**PLANNING COMMISSION
SITE PLAN COMPATIBILITY WAIVER REQUEST REVIEW SHEET**

CASE: SP-2021-0043C

PROJECT NAME: 2012 E. Cesar Chavez

The applicant requests a waiver from a 50-foot to an approximately 26.67-foot compatibility setback for a pool to serve the proposed 14-room hotel.

SITE PLAN APPROVAL SHEET 08 OF 21

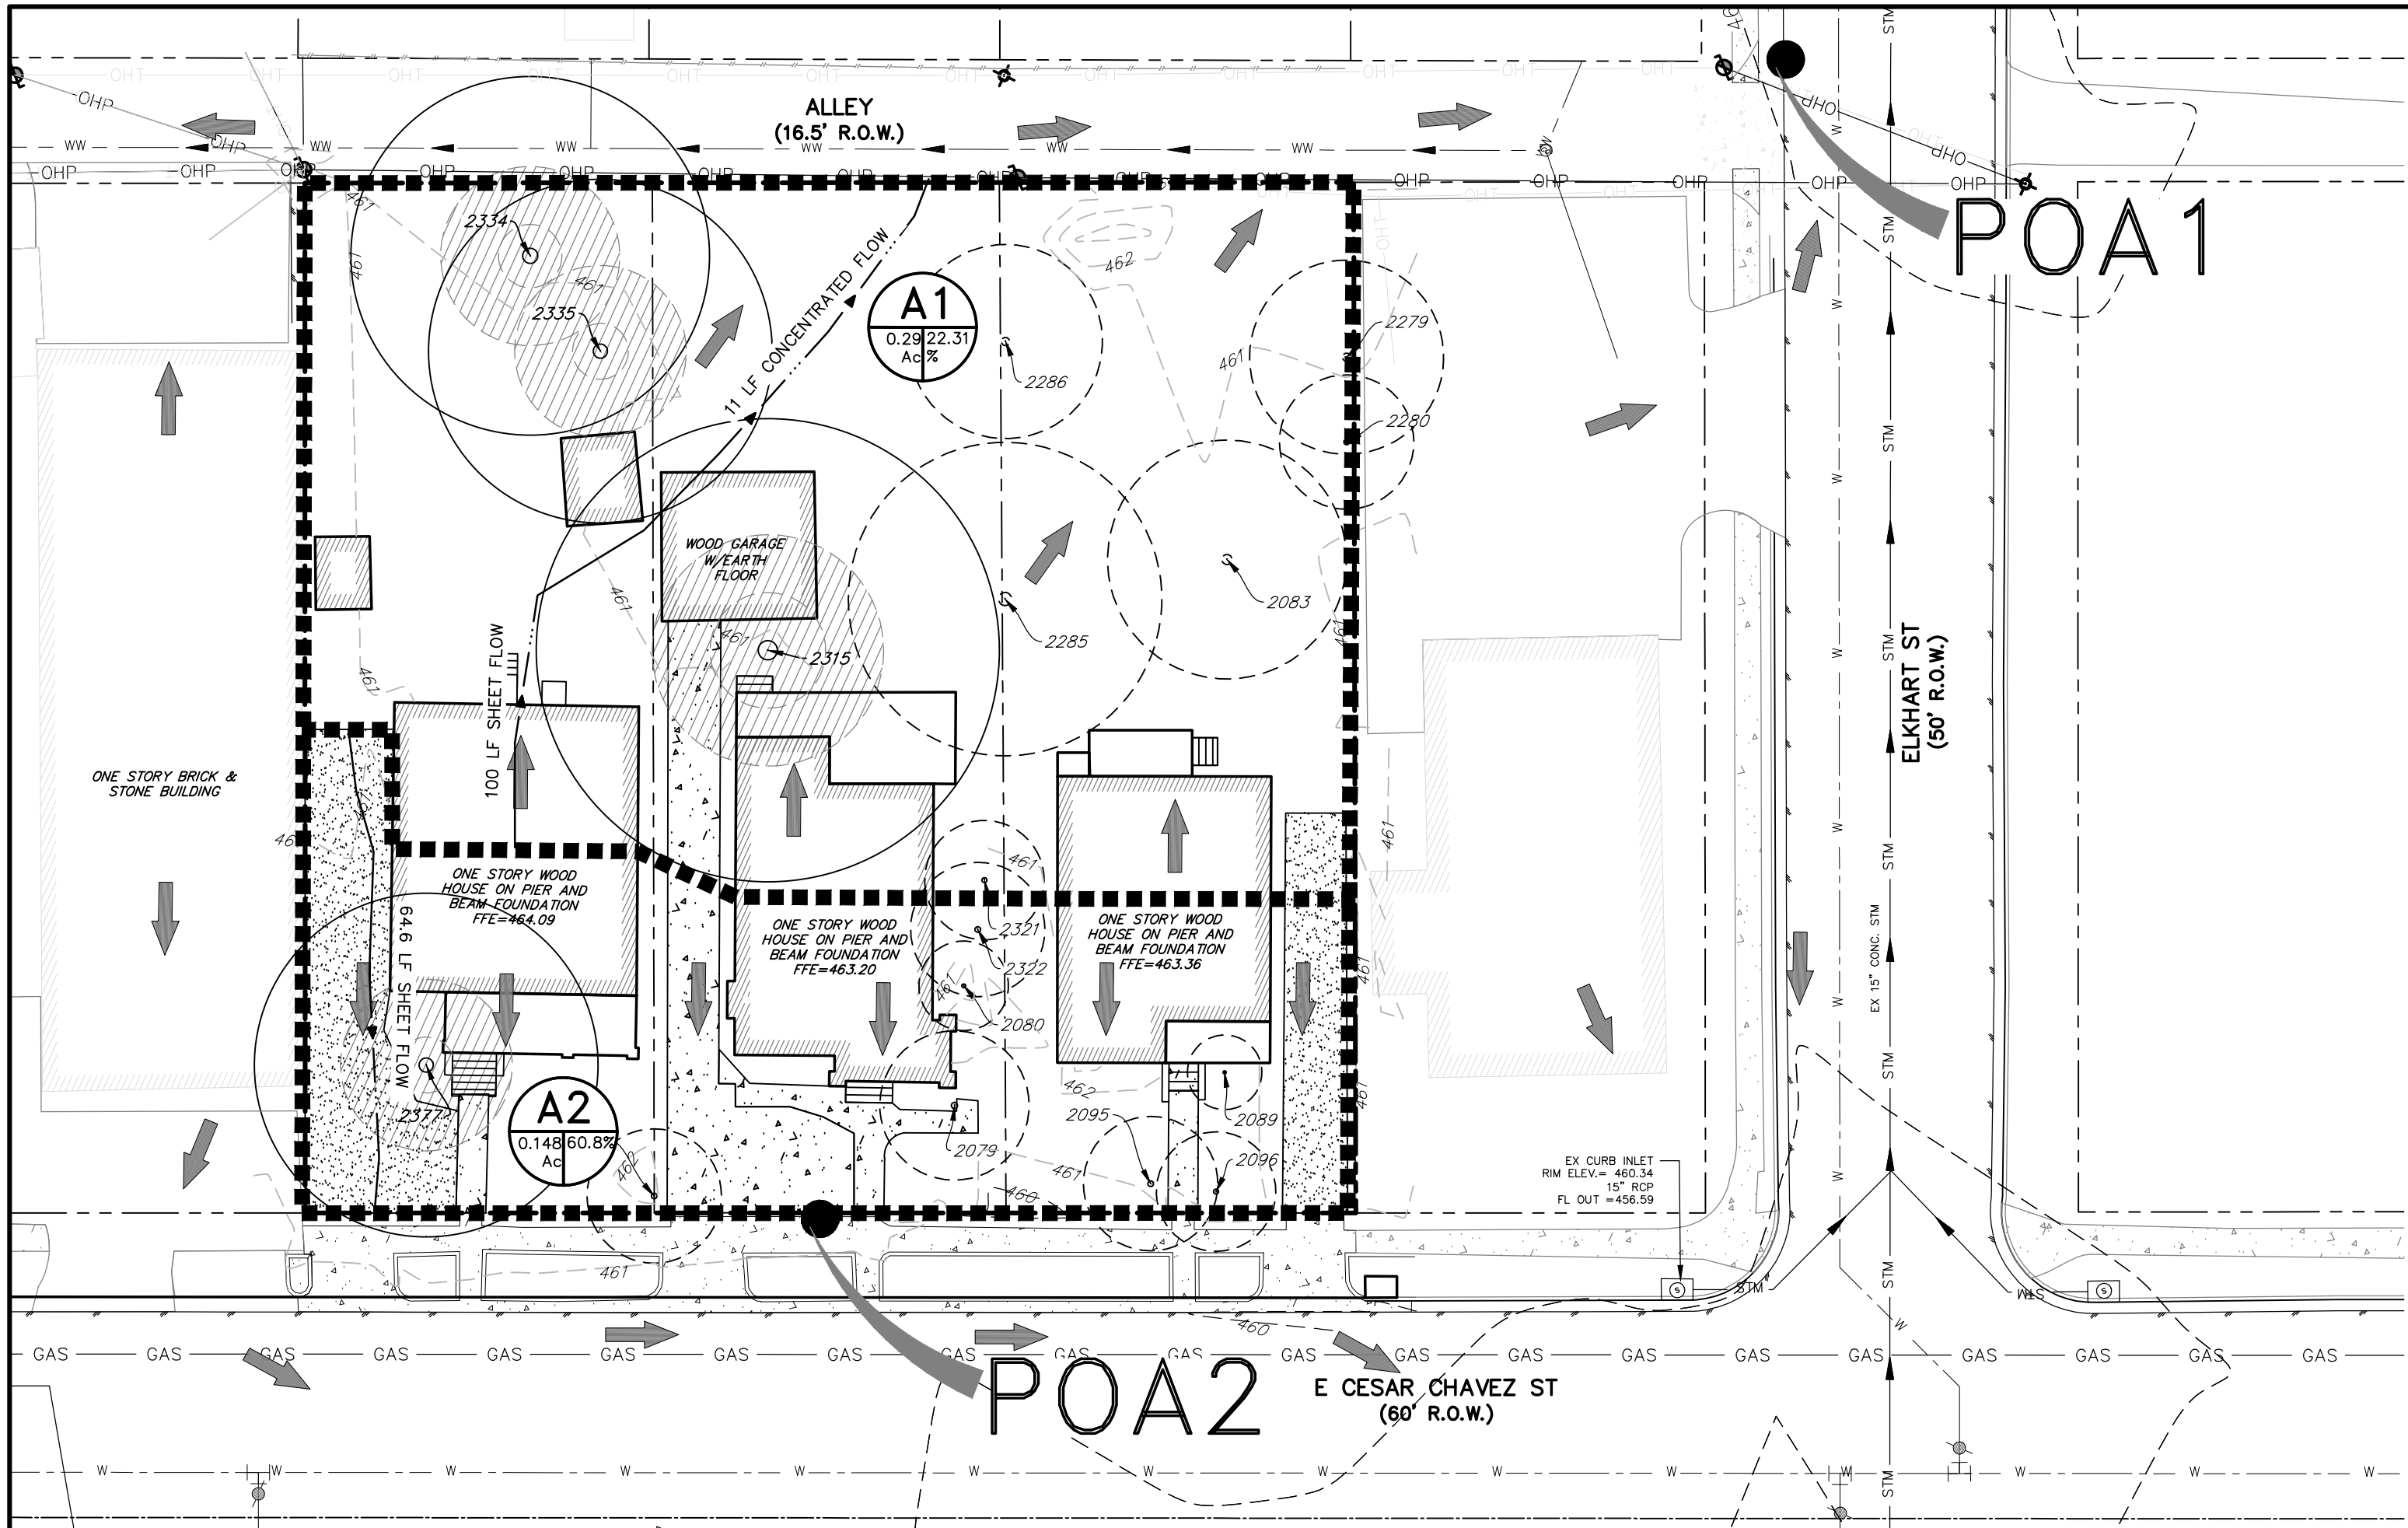
Staff recommends approval of the waiver from LDC Section 25-2-1067 to reduce the Compatibility setback requirement from 50 feet to approximately 26.67 feet from adjacent SF-3-NP zoned properties used as single family. The pool will be located behind a privacy fence.

Land Use: The applicant requests a waiver from a 50-foot to an approximately 26.67-foot compatibility setback for a pool to serve the proposed 14-room hotel. The site is adjacent to single-family houses to the north, commercial to the east and west, and commercial and single-family across E. Cesar Chavez to the south. The 26.67' spacing includes the 16.5'-wide alley between the proposed hotel and the single-family dwellings. The site plan will comply with all applicable regulations upon site plan approval.
